Rev A	31/03/23	Issued for Planning
		Revisions as noted
First Issue	15/07/22	Issued for Planning

Project 14 John Street

Drawing Title: Proposed North West (Rear) Elevation

Drawing No. A2102 Rev. A

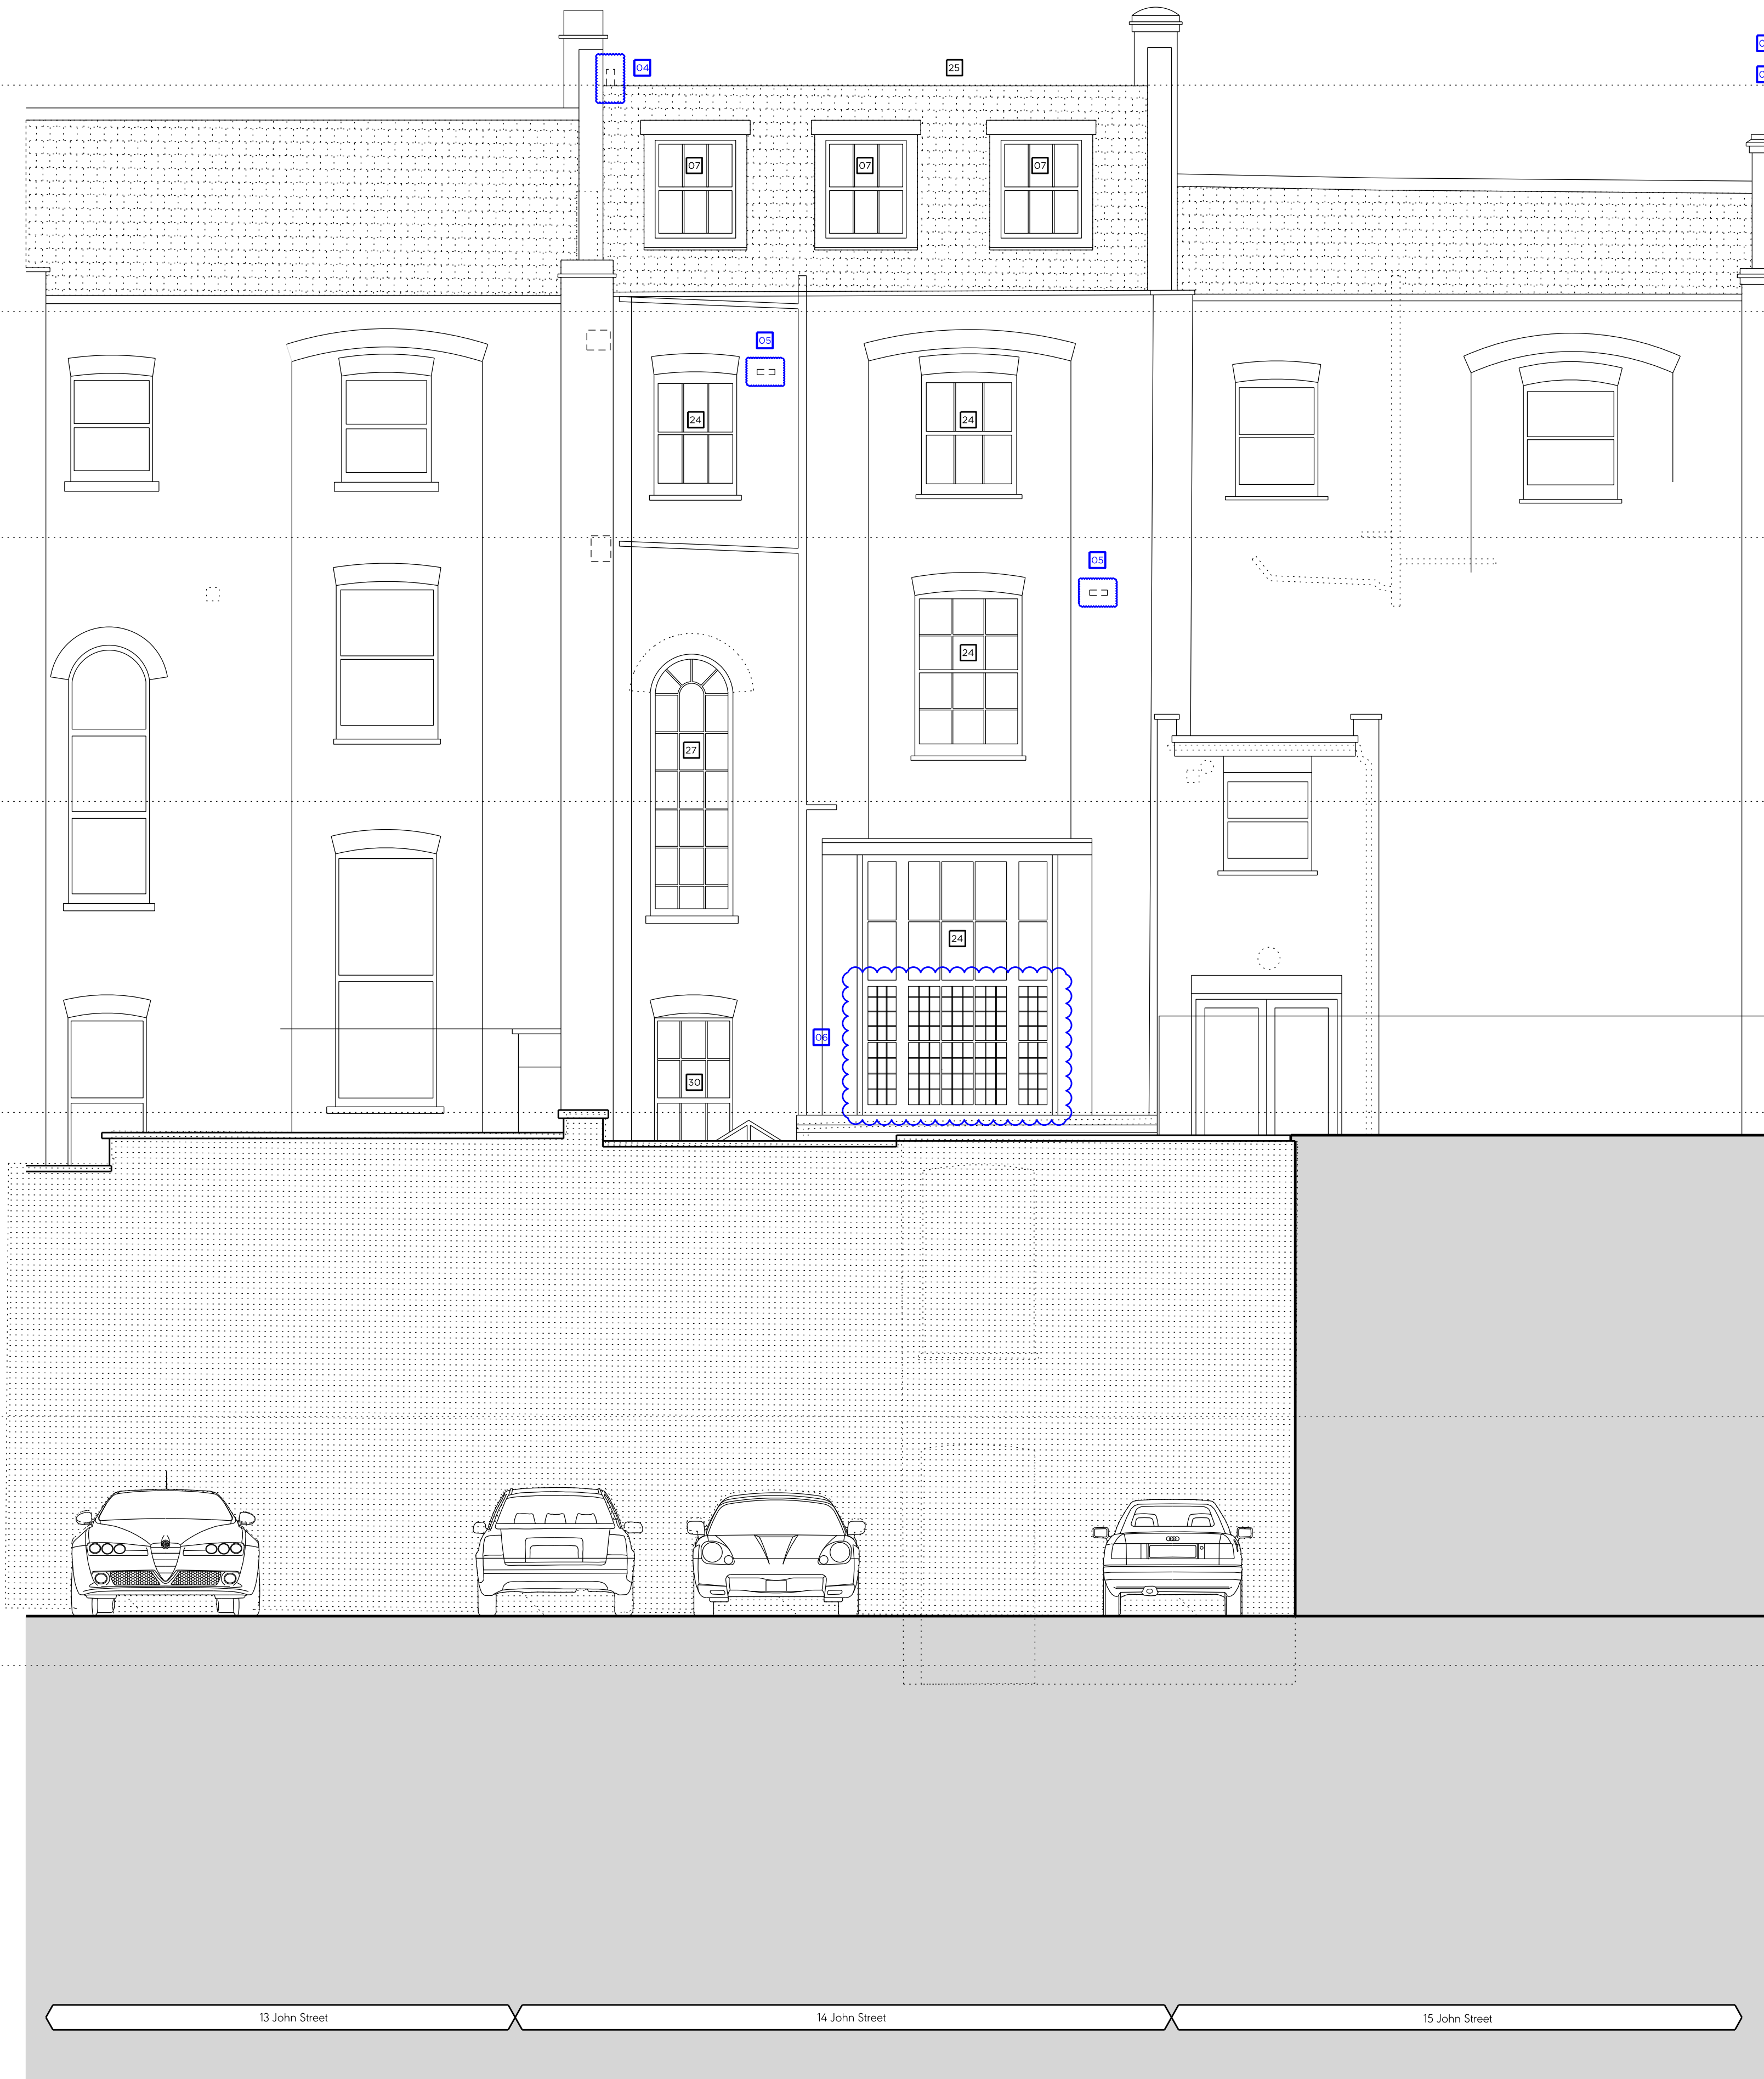
Revision Notes 31/03/2023:	
01	Demolition of extension to create terrace omitted
02	Courtyard elevation amended
03	Notation added to confirm proposed partition
04	Vents in roof shown
05	Proposed airbricks shown in elevation
06	Existing leaded lights shown in elevation
07	Existing RWP shown on drawing
08	Annotation added for clarification
09	Demolition of partition for proposed door shown
10	Powder Room moved to rear of Study
